MILITARY SPECIFICATION

ELECTRONICS MODULE ASSEMBLY

1.1 Scope. This Specification covers the performance and acceptance inspection requirements for the Electronics Module Assembly associated with the M130 Aircraft General purpose Dispenser.

Figure 2 Dispenser system test axis orientation

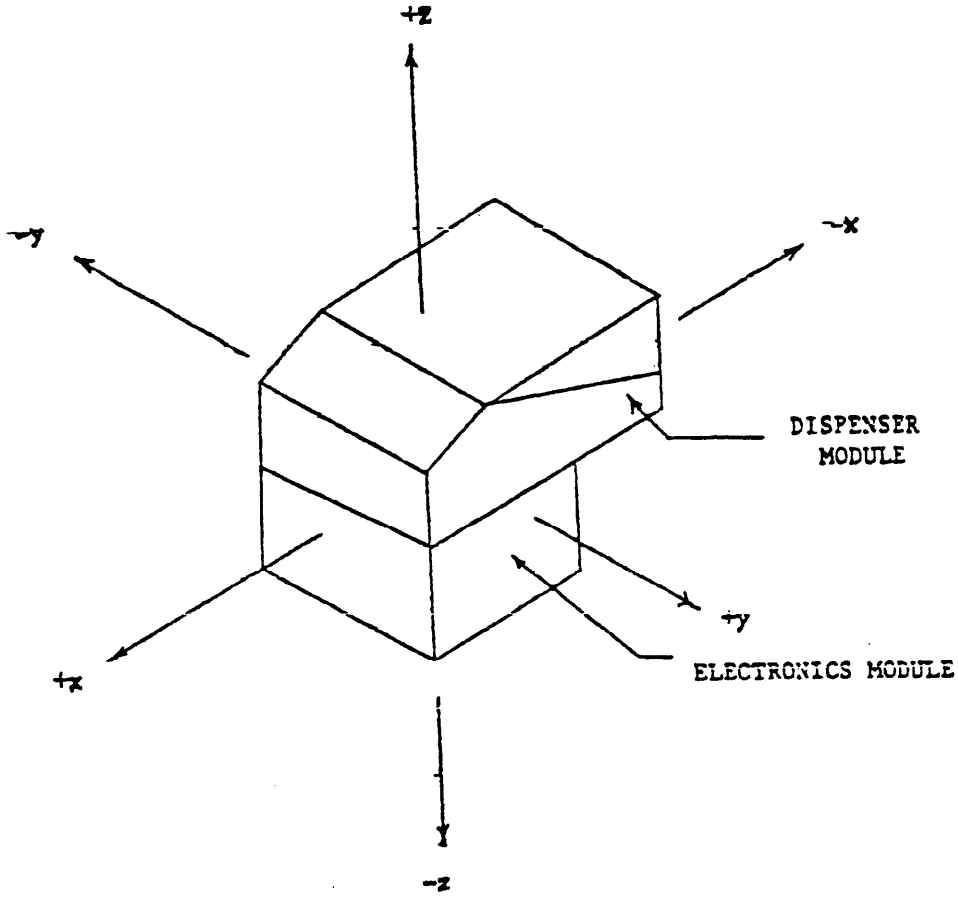
Line 5: Delete "... in Figure 1. The payload . . . for this test” and substitute “... in Figure 2. The payload module shall be loaded with thirty (30) ballast flares, dwg. 12589959, (preferred) or with thirty (30) inert flares for this test".
